Replacing Integrated Balancing Valves in Purmo DiaNorm Radiators

Radiators manufactured between 1995 to 2011

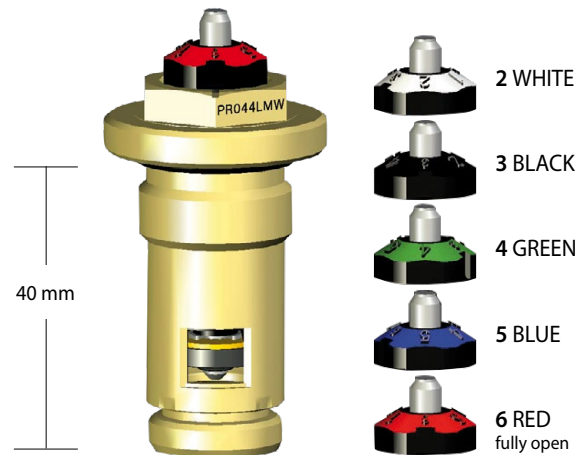
The ID number printed on these valves begins with "OV".

All balancing valves were shipped from the factory fully open (with a setting of "6" on a scale of 1-6). The valve setting dial color is either black or brass.

Be sure to specify that you need the older type as the size of the newer valve is not compatible with radiators manufactured before 2011.

When ordering replacement GH insert valves use **part# 101 8080**
